ADDENDUM NO.1

RFB - 927940-03

WRC Fire Alarm Phase 4

Project: 9279.40 BI#03 Fire Alarm Phase 4

00-G002

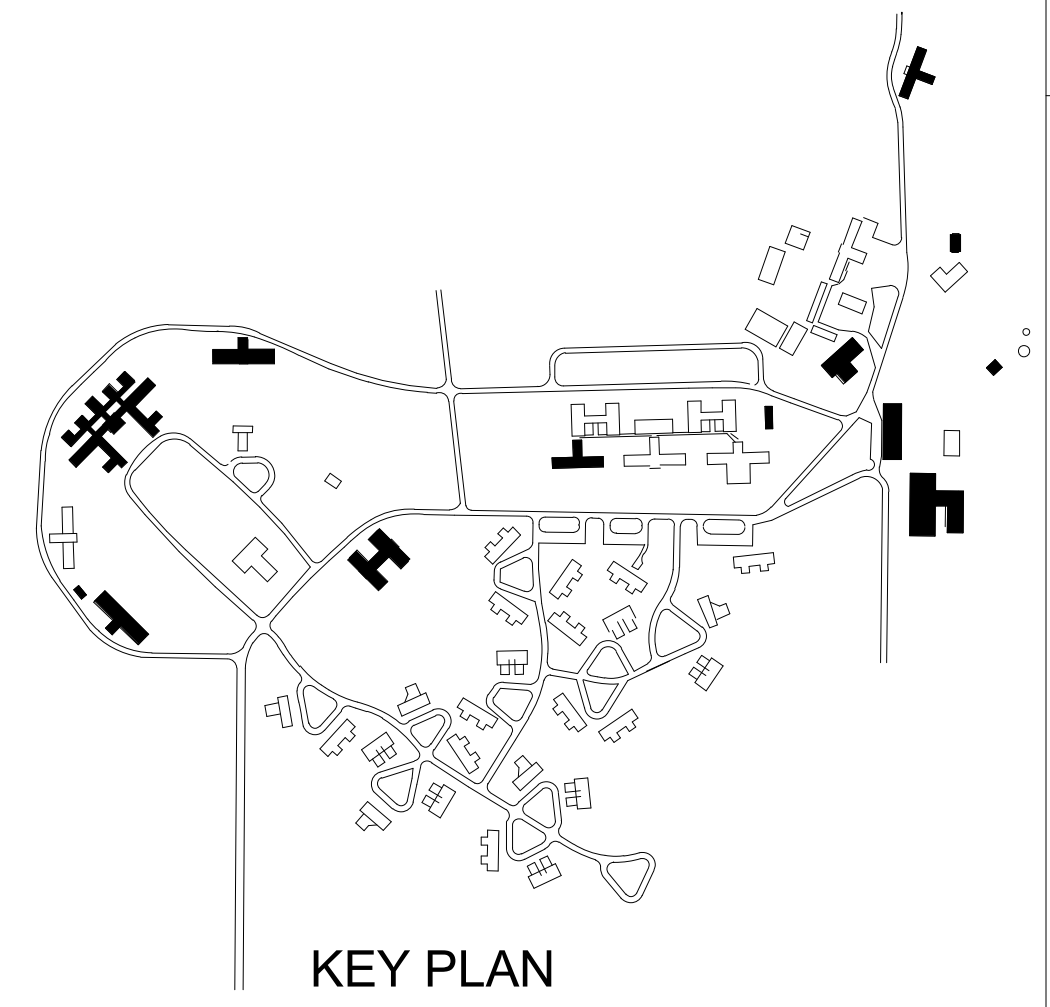
- 1. What is the correct method for installing fire alarm cabling above finished ceilings and along walls?
A) Notes about installing cabling are added to drawings 00-E000 and 00-G002. Refer to clouded drawings in the Addendum #1.**
- 2. Where are the patch panels located?
A) Drawings are updated to add information on connecting the patch panels to the new FACP. Refer to clouded drawings in the Addendum #1 on drawing sheets 02-E301, 14-E301, 17-E301, 22-E301.**
- 3. What is the preferred method for removing the existing fire alarm devices?
A) Disconnect power, remove the device and all related cables, and leave boxes and conduit in place.**

5. Fire alarm cabling is typically run separately from other electrical cabling and, by code, should not share conduit with other wires, including low-voltage systems. Does this requirement still apply in locations where fire alarm cabling is proposed to be installed in conduit with fiber?
 - A) Conduit is added for fire alarm cabling to Employee Home. Refer to clouded drawings in the Addendum #1

KEYNOTES	
KEY	NOTE
00-GE01	EXISTING CONDUIT INSTALLED BETWEEN BUILDING. USE CONDUIT TO ROUTE FIRE ALARM CABLING FOR BUILDINGS WITHOUT FIRE ALARM CONTROL PANEL.
00-GE02	FURNISH AND INSTALL NEW SINGLE MODE NETWORK CARD IN EXISTING FIRE ALARM CONTROL PANEL. FIRE ALARM CONTROL PANEL TO BE CONNECTED BACK TO CAMPUS MAIN PANEL IN ADMINISTRATION BUILDING VIA NEW SINGLE MODE FIBER NETWORK. REMOVE OLD SIEMENS FIRE ALARM PANEL AFTER ALL NEW FIRE ALARM PANELS ARE OPERATIONAL AND INSPECTED.
00-GE03	FURNISH AND INSTALL RELAY TO MONITOR EXISTING FIRE ALARM CONTROL PANEL LINDEN COURT. RELAY TO BE CONNECTED TO FIRE ALARM PANEL IN CAMPUS FOOD SERVICE. COORDINATE WITH OWNER THE PROGRAMMING OF ALARM MESSAGE AT MAIN CAMPUS FIRE ALARM PANEL. IN ADMINISTRATION WHEN LINDEN COURT FIRE ALARM PANELS GO INTO ALARM.
00-GE04	NEW FIRE ALARM CONTROL PANEL INSTALLED IN PREVIOUS PHASE.
00-GE05	DIRECTIONAL BORE NEW 2" CONDUIT FROM EMPLOYEE HOME TO MYERS HALL. FIRE ALARM DEVICES IN EMPLOYEE HOME TO BE CONNECTED TO EXISTING FACP IN MEYERS HALL.

(#9279.40) WRC Fire Alarm Phase 4
02 - ADMINISTRATION

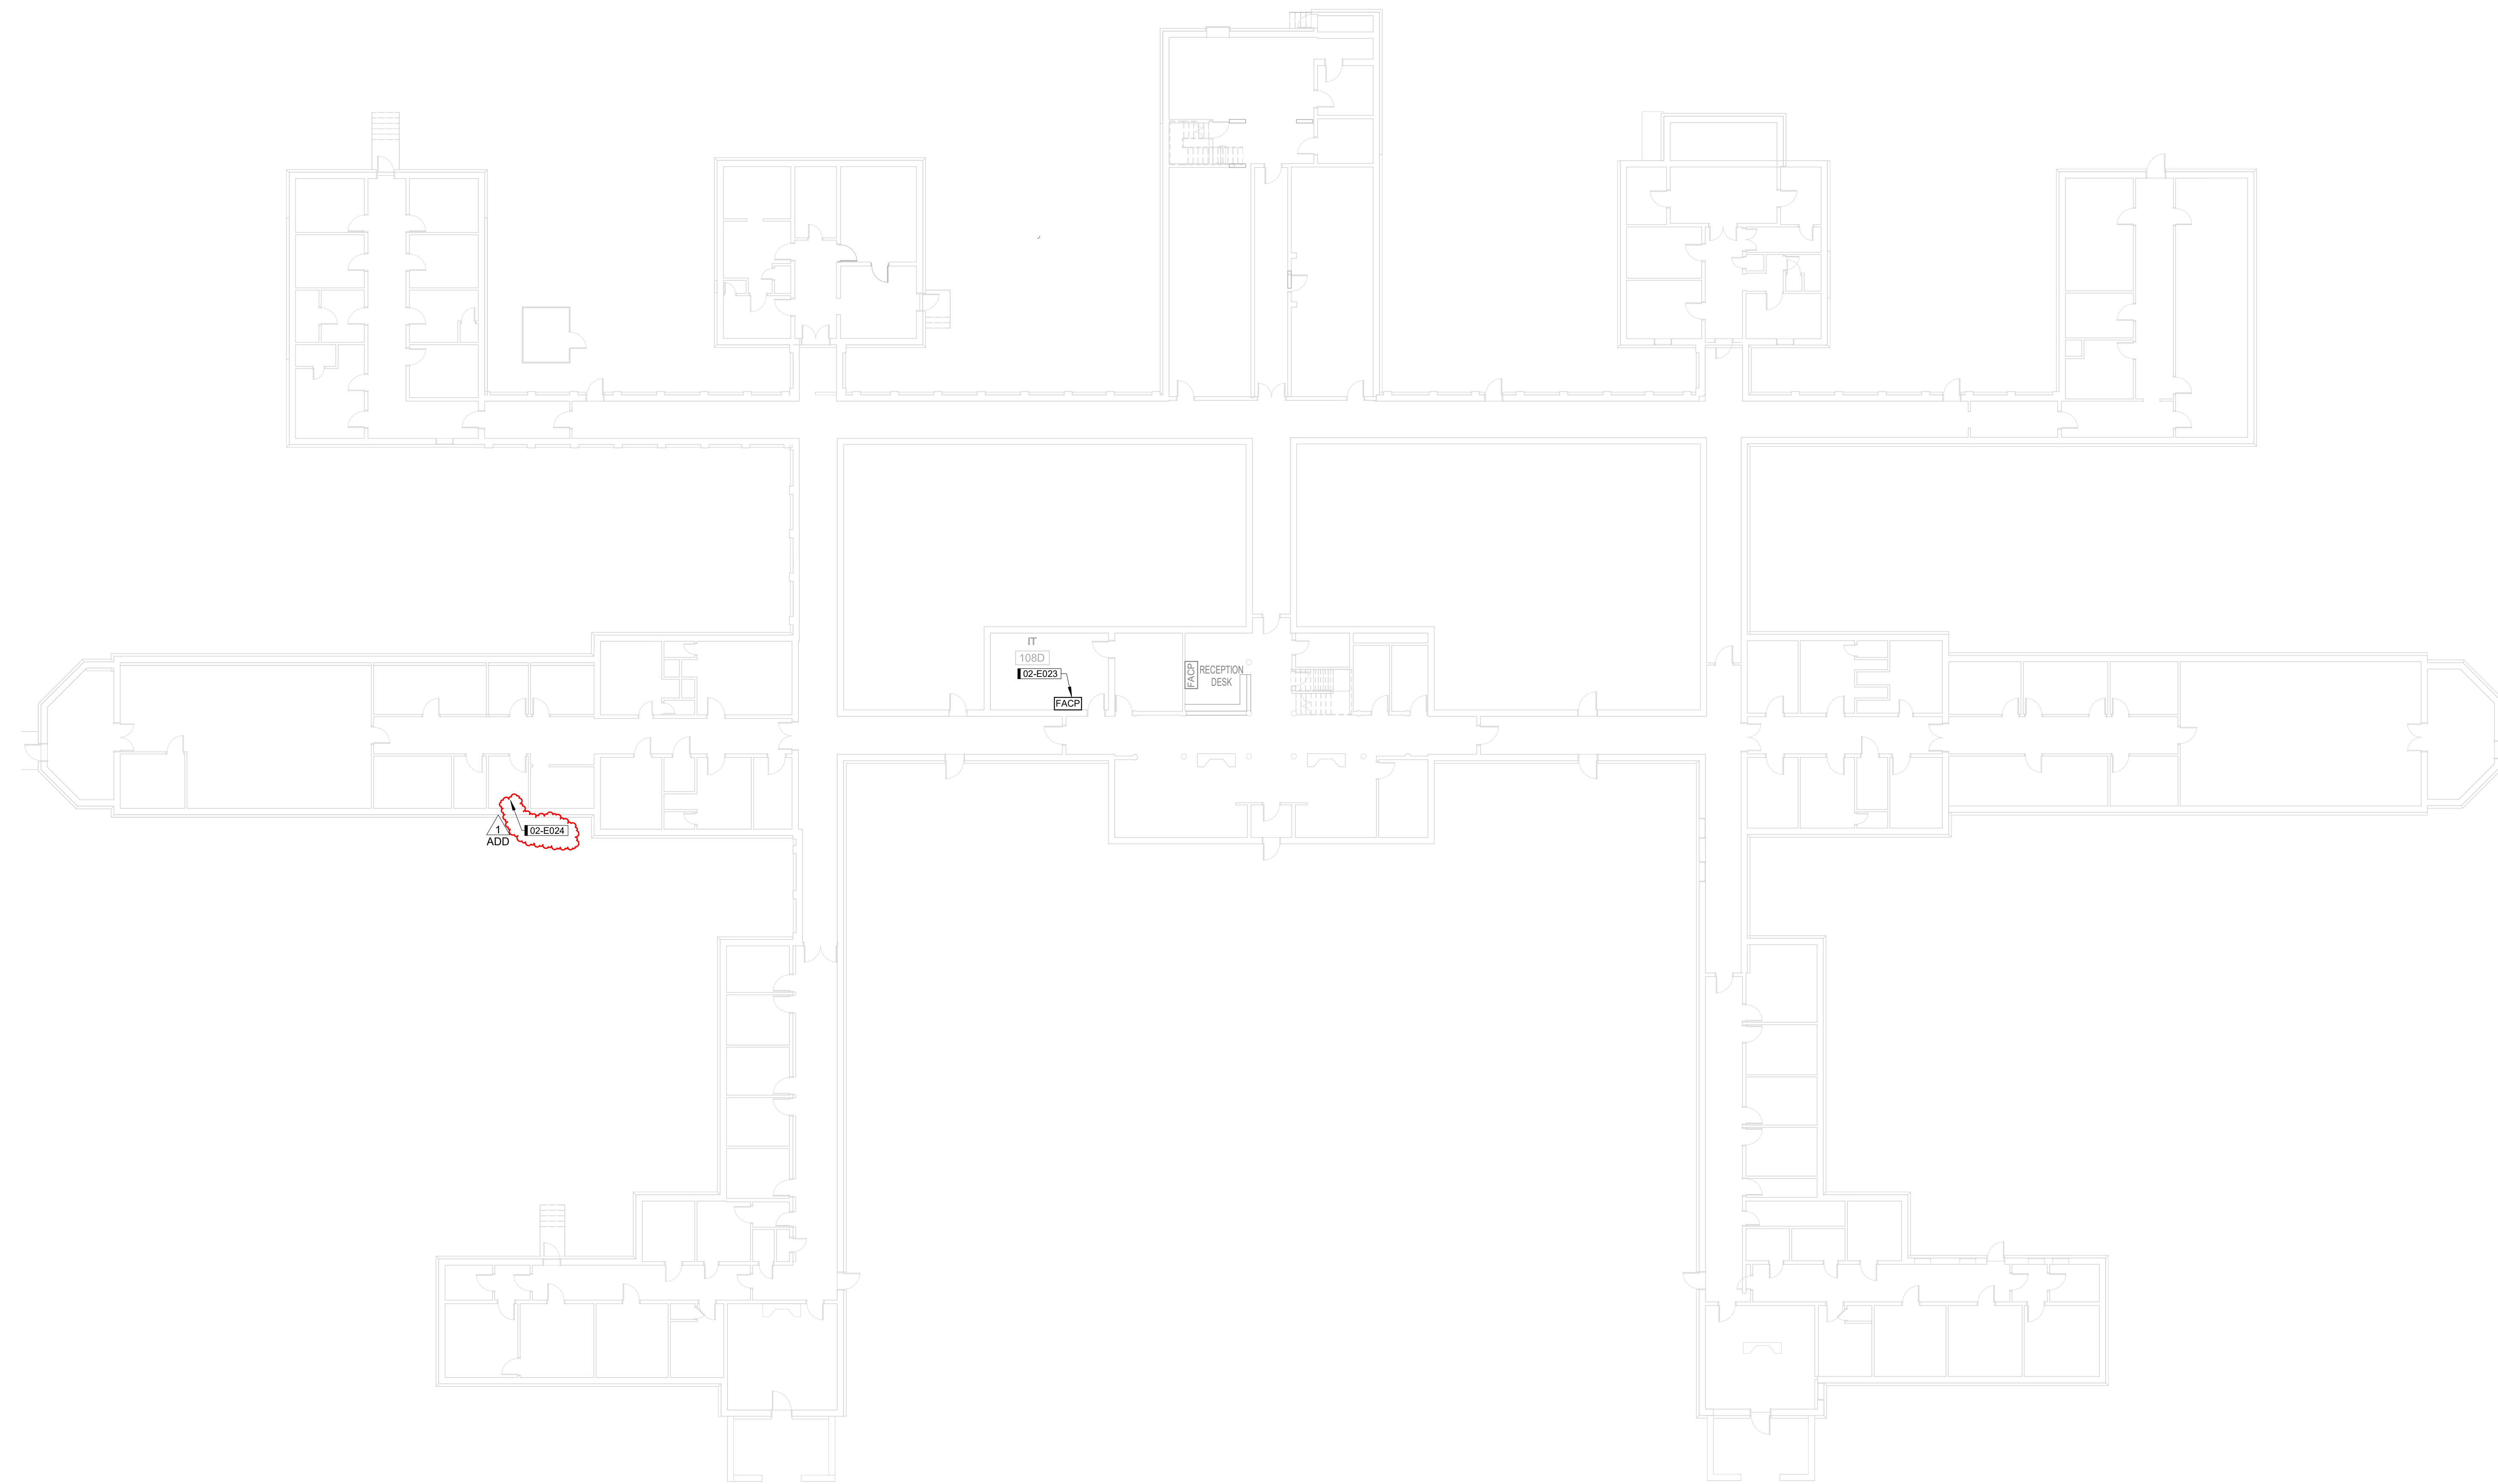
8. Where are the electrical panels located to get power to the new FACP's?
 - A) Existing circuit that feeds existing FACP's will be extended to feed the new FACP's

KEYNOTES	
KEY	NOTE
02-E023	FURNISH AND INSTALL SECOND CAMPUS FACP. CIRCUIT TO SAME CIRCUIT AS FIRST CAMPUS FACP. FURNISH AND INSTALL NEW CAMPUS FIRE ALARM COMPUTER AT RECEPTION DESK. COMPUTER TO MONITOR AND PAGE BOTH CAMPUS FACP PANELS.
02-E024	EXISTING FIBER ENTRANCE LOCATION. FURNISH AND INSTALL 6 STRAND OF SINGLE MODE FIBER FROM FIBER ENTRANCE TO FACP LOCATION. INSTALL FIBER IN 3/4" C. CONNECT FACP TO SINGLE MODE FIBER NETWORK.

1 BASEMENT LEVEL - FIRE ALARM RENOVATION PLAN
1/8" = 1'-0" 0' 12"

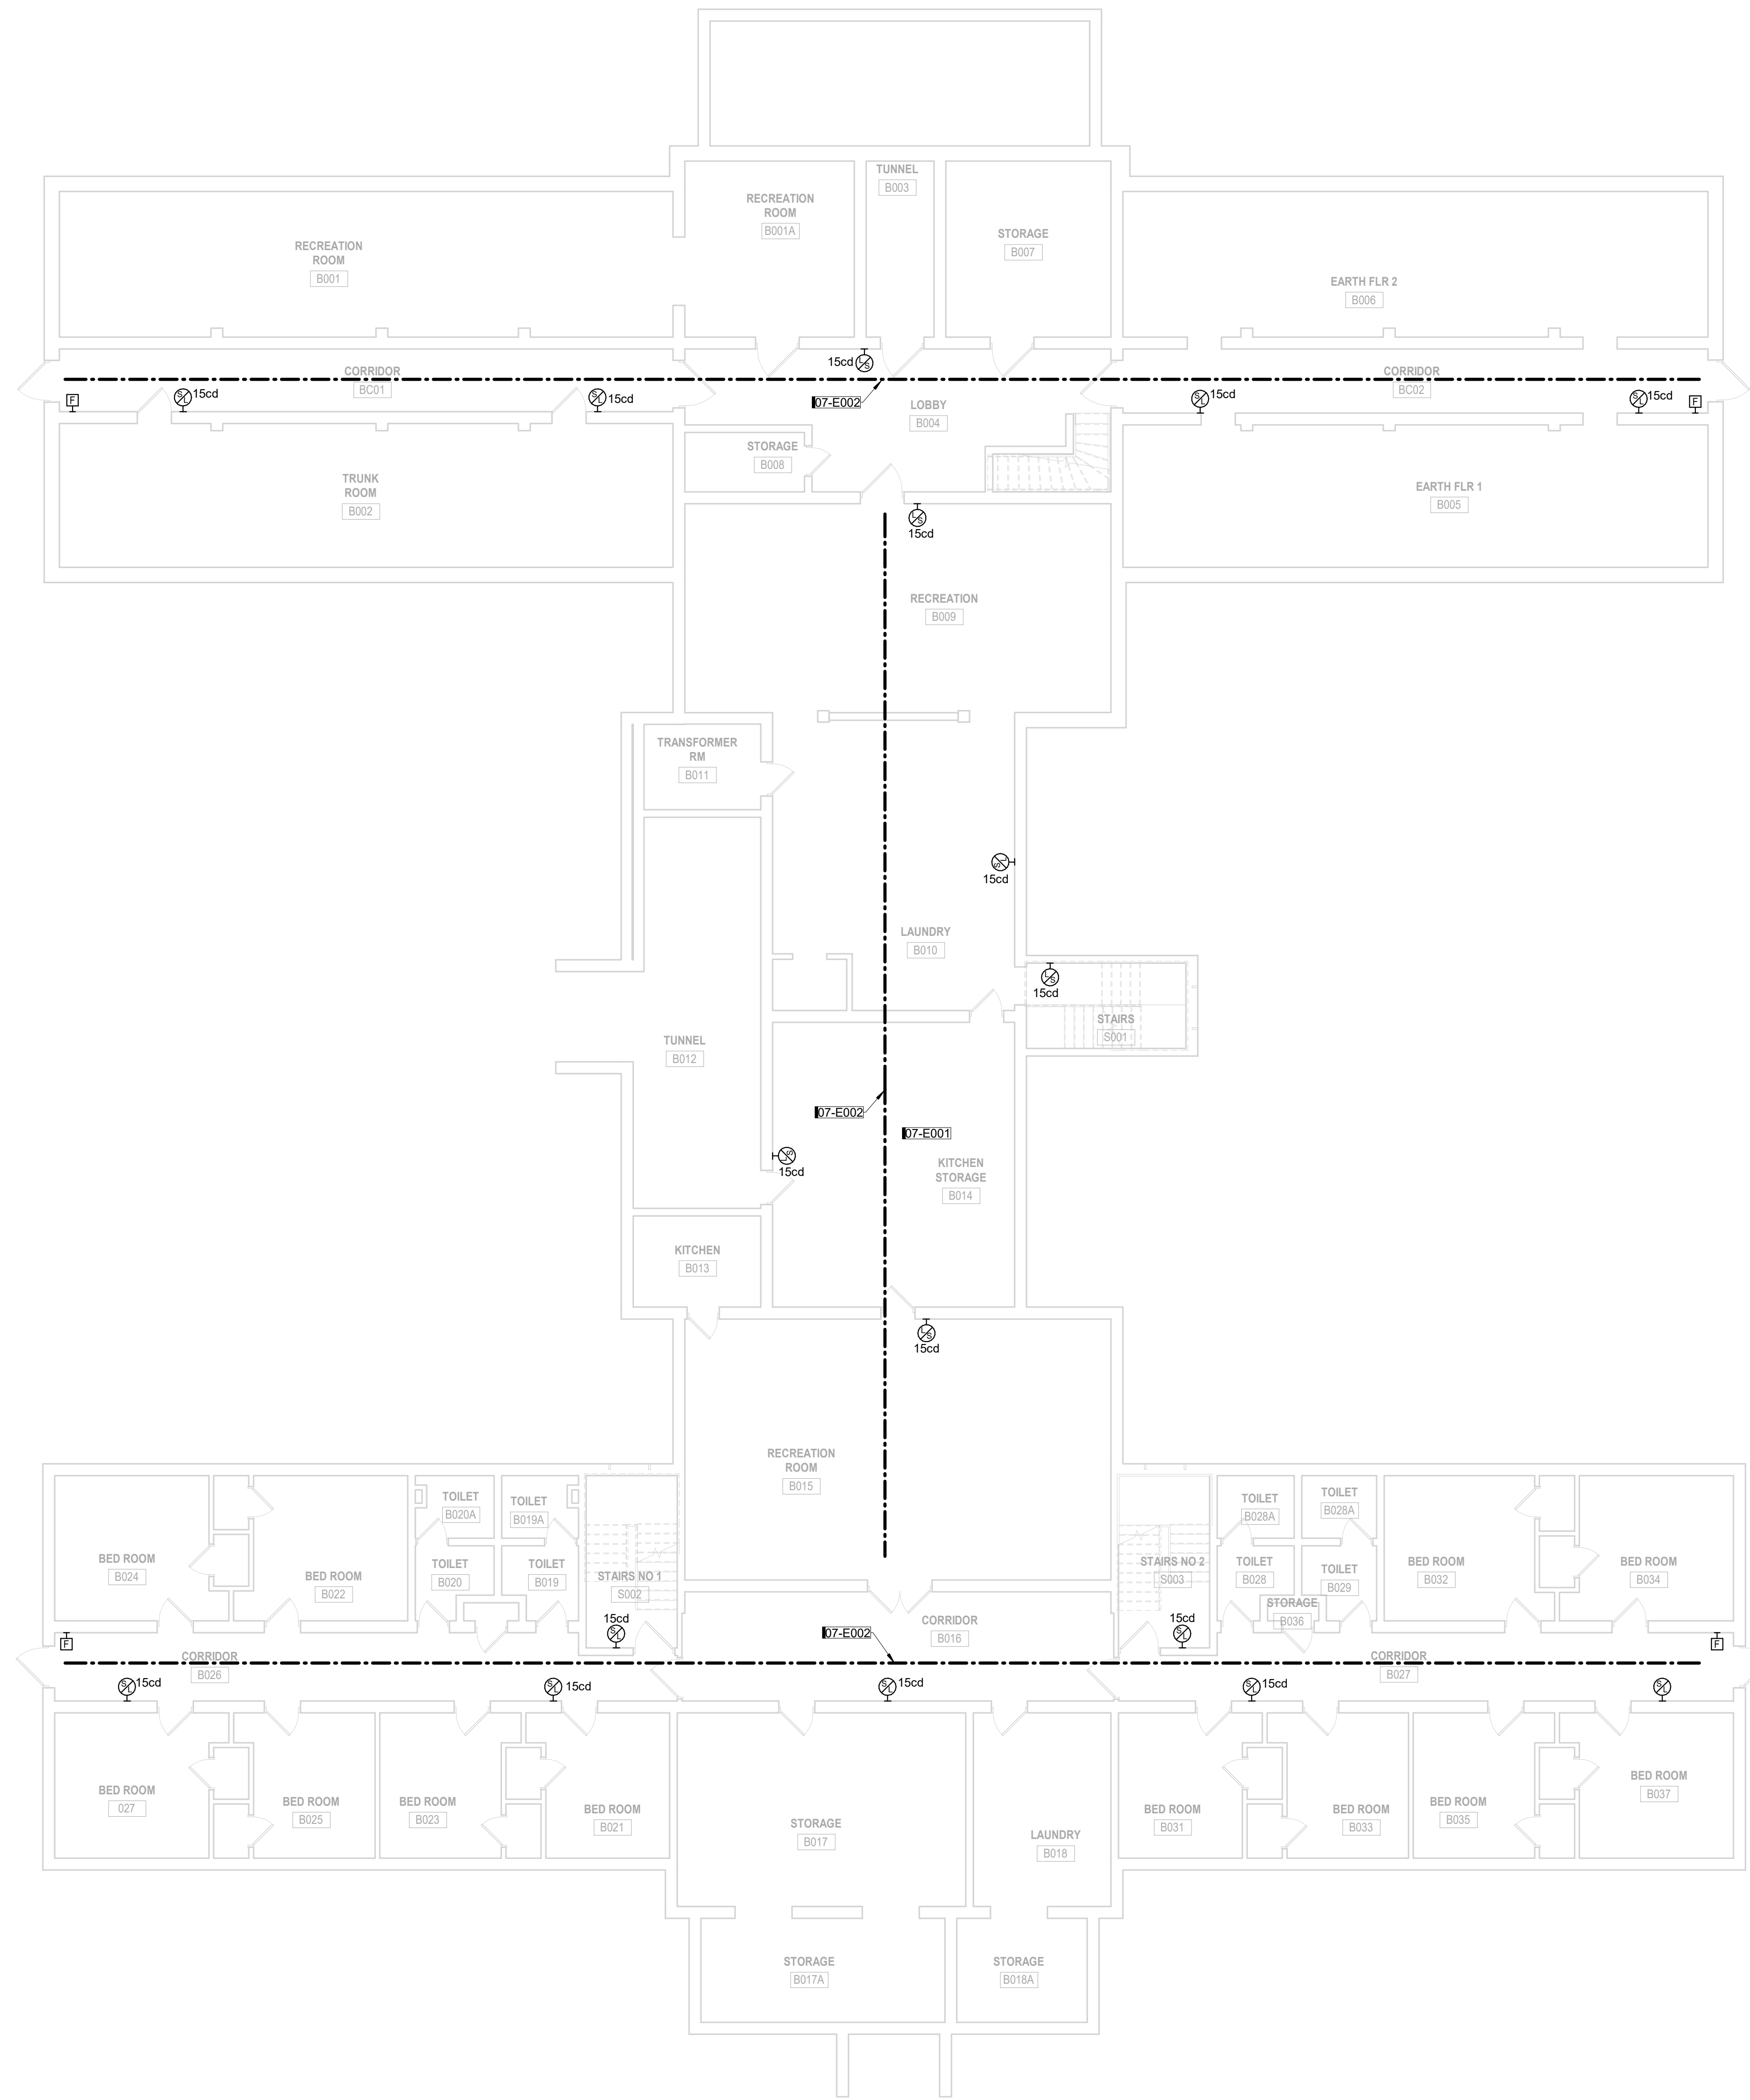
4. How should linear heat detection wiring be installed in areas without ceilings compared to areas with ceilings?
 - A) 00-E000. Refer to clouded drawings in the Addendum #1.

KEY	NOTE
07-E001	FIRE ALARM IN EMPLOYEE HOME CONNECTED TO FIRE ALARM CONTROL PANEL IN MYERS HALL. ROUTE FIRE ALARM CABLING BETWEEN BUILDING VIA NEW CONDUIT. REFER TO 00-G002 FOR CONDUIT ROUTING. FIRE ALARM ANNUNCIATION ONLY TO ACTIVATE IN THE BUILDING WHERE DETECTION DEVICE IS ACTIVATED.
07-E002	LINEAR HEAT DETECTOR WIRE.
